<b>Delegated Report</b>		<b>Analysis sheet</b>		<b>Expiry Date:</b>	22/06/2020
		N/A		<b>Consultation Expiry Date:</b>	29/07/2020
<b>Officer</b>			<b>Application Number(s)</b>		
Kristina Smith			i) 2020/1828/P ii) 2020/2577/L		
<b>Application Address</b>			<b>Drawing Numbers</b>		
Land Adjacent to Jack Straws Castle North End Way London NW3 7ES			See decision notice		
<b>PO 3/4</b>	<b>Area Team Signature</b>	<b>C&amp;UD</b>	<b>Authorised Officer Signature</b>		
<b>Proposal(s)</b>

i) Erection of two three-storey (plus basement) dwellinghouses (Class C3) on rear part of car park set behind associated landscaping, refuse and cycle stores and reconfigured car parking					
ii) Erection of two three-storey (plus basement) dwellinghouses on rear part of car park as a side extension to Jack Straws Castle plus associated underpinning of adjacent basement					
<b>Recommendation(s):</b>		i) Refuse Planning Permission ii) Refuse Listed Building Consent			
<b>Application Type:</b>		i) Full Planning Permission ii) Listed building consent

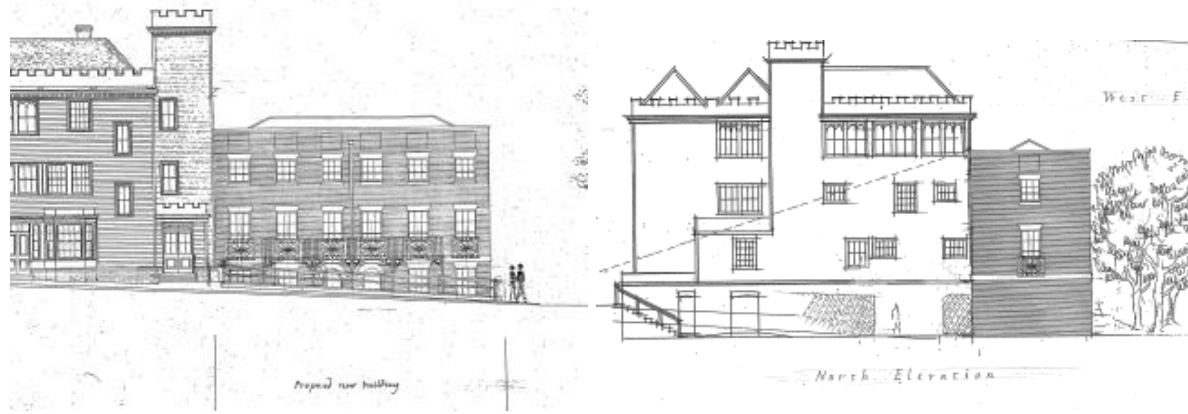
3.14. In comparison, the proposal for a taller and wider development, 3 storeys high across the whole carpark's back edge, is clearly larger than the previous 2004 scheme. This is demonstrated by the comparison extracts of front and side elevations of both the 2004 and 2017 schemes shown below. The drawings from the 2017 application are being used instead of the current application as the drawings do not show Jack Straw's Castle and therefore it is difficult to understand the impact. It is stressed, however, that the height, width and massing are the same and the only changes relate to detailed design at roof level and on the side elevation.

- 3.15. In light of these appeal decisions, the current proposal would have a far more substantial and consequently unacceptable impact in enclosing the open space of the carpark. Thus, it is argued that the currently proposed houses, and quite possibly any structure larger than a single storey structure, would continue to erode the distinctive quality of the carpark in its role as an open area of curtilage around the main castellated block.

- 3.16. It is acknowledged that there are subtle yet important differences between the past and more recent schemes. As demonstrated in the comparison images above, the 2004 appeal scheme projected beyond the junction between the rendered rear section of the building (later addition) and the main weather-boarded façade (original building); it was designed as an extension in matching pastiche design; and the carpark had a solid boundary around part of it. In contrast, the new scheme is set back further and respects the junction between both elements of the main building; it is conceived as a distinctive separate building with contrasting design idiom; and the carpark is left largely open as existing. These are considered to be positive moves in design terms; however, they are still far from sufficient to sway the balance.
